,	
Project No.	Zone Change 2001Z-060U-14
Associated Case	PUD Proposal 2003P-007U-14, Cumberland Yacht
	Harbor
Council Bill	BL2003-1462
Deferral	This item was deferred at the May 22, 2003, meeting.
Staff Reviewer	Leeman
Staff Recommendation	Approve with conditions.
APPLICANT REQUEST	Rezone 40 acres from residential single-family (RS10) to mixed-use general (MUG) district property at 252 Donelson Hills Drive, along the north side of Lebanon Pike.
Existing Zoning	
RS10 district	RS10 zoning is intended for single-family homes on 10,000 square foot lots at a maximum density of 3.7 dwelling units per acre. The current zoning would permit 148 single-family lots on this property.
Proposed Zoning	
MUG district/PUD	Mixed Use General zoning is intended for a moderately high intensity mixture of residential, retail, and office uses. It also permits a marina under the boat dock use category. MUG permits a maximum floor area ratio (FAR) of 3.0, and a maximum height of 65 feet at the setback line. (See PUD proposal 2003P-007U-14).

Project No. Project Name Council Bill Associated Case Deferral Staff Reviewer Staff Recommendation	Planned Unit Development 2003P-007U-14 Cumberland Yacht Harbor BL200

PLAN DETAILS

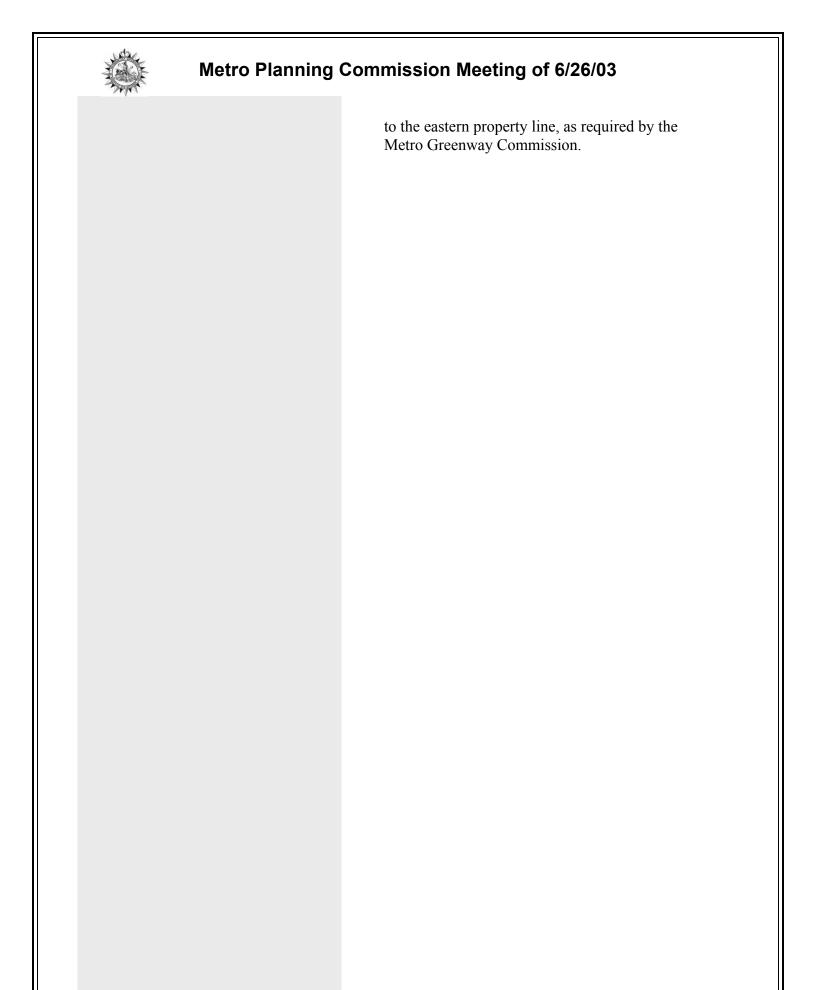
The proposed plan adds 74 multi-family units to an area of the plan originally slated for development, but subsequently revised for open space.
